The full responses to the 3 reviewers are attached below, point by point. In addition, during the revision process some minor awkward wordings were improved, as seen in the track-changes manuscript file.

The CLARA climate data record is the longest remote sensing based record for global surface variables, and has unique significance to environmental and climate studies. This manuscript presents an overview to the latest version of CLARA-A3 albedo product, including its algorithm update and features of dataset. The content is relevant to the scope of ESSD, and will be helpful to data users. The aim of this manuscript is to clearly describe the strength and limitations of the dataset. In this consideration, some questions and revision suggestions are raised as follows:

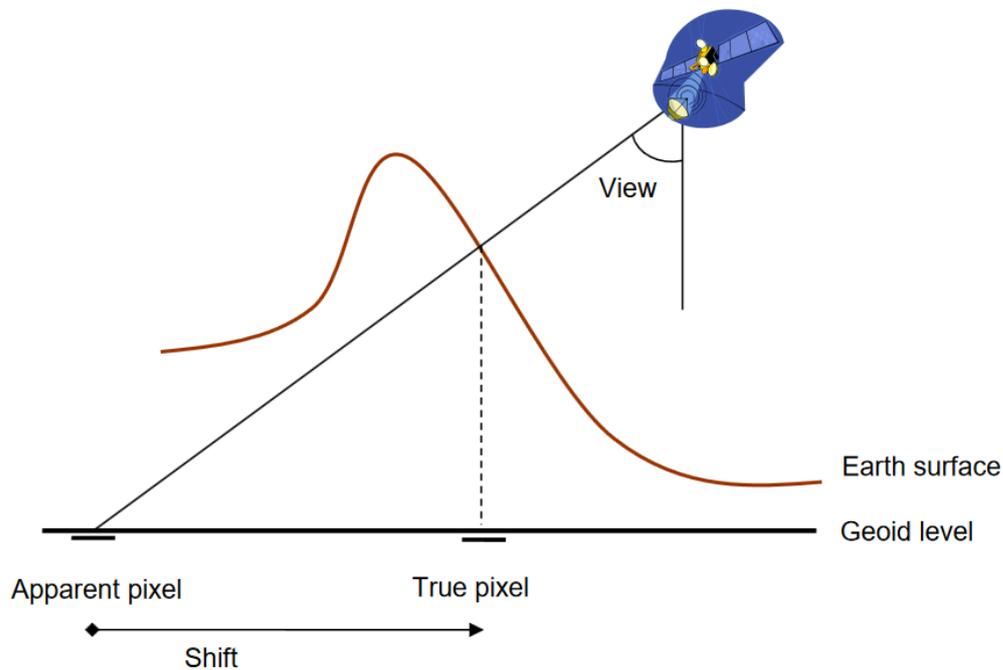
2. In table 1, I just ask a question: is there any change in the algorithm of albedo retrieval over ocean surface?

The algorithm itself remains unchanged, but we have removed the normalization to 60 degrees SZA to maintain internal consistency in treatment of CLARA albedo estimates over all surfaces on Earth. Also, now the WAL and BAL estimates are also available over ocean surfaces, as noted in the table 1.

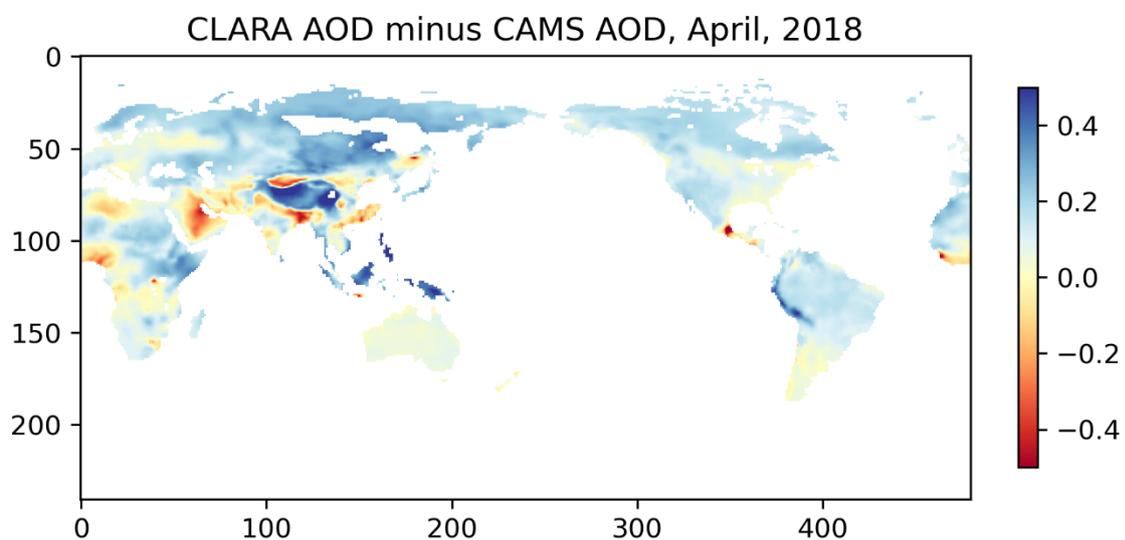
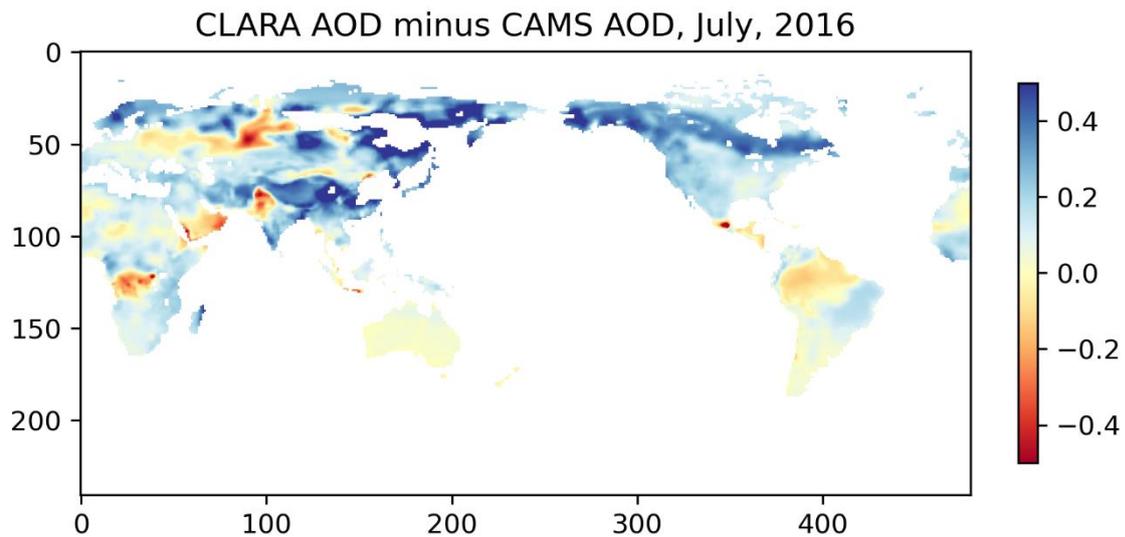
- Does the SRTM have the DEM data between the surface that lies between the 56 degrees south to 60 degrees south latitude? As we all know, the SRTM's radars can cover most of Earth's land surface that lies between 60 degrees north and 56 degrees south latitude.

Thank you, this was indeed a mistake in the text. The SRTM coverage is 60 N – 56 S, with GTOPO30 being used elsewhere. We will revise the text accordingly.

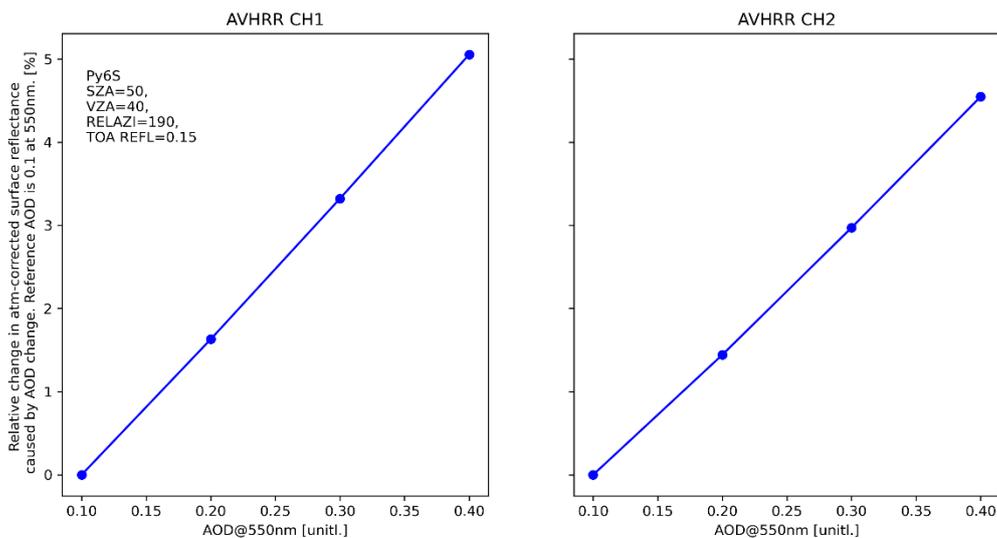
- I find that you used the AOD data from 2015 to 2014 to replace the AOD data from 2005 to 2014. How many unnecessary uncertainties were introduced?

Yes, years 2015-2020+ are covered by a climatology because of emerging issues in our aerosol data source instrument OMI. While this certainly does introduce additional uncertainty, as noted on lines 117-119, it is difficult to quantify the exact additional uncertainty. To obtain a general estimate for the reviewer, we obtained the CAMS monthly mean AOD550 data and calculated the differences to our AOD climatology for some example cases. Figures below illustrate the differences for April 2018 and July 2016. The data is resampled to the CAMS grid and resolution.

Larger differences occur over the boreal zone in summer, most likely with major contributions due to aerosols from forest and brush fires. Other large differences may occur over some tropical rain forest regions in Asia, as well as the Tibetan Plateau where CAMS AOD exhibits very small values, perhaps too small to be realistic.

To place these differences in context, we further did ATM simulations with the Py6S code (Wilson, 2013), as illustrated below. For an example case of (boreal) forests with a typical surface reflectance of 0.15 and viewing/illumination geometry matching common cases of AVHRR observation in summer, we find that variability of 0.3 in AOD can cause differences of up to 5% (relative) in surface reflectance for both AVHRR CH1 and CH2, with the broadband effect being in the same order of magnitude. We can therefore estimate that typical additional relative uncertainty is likely in the 0-6% range, although larger effects remain of course possible.
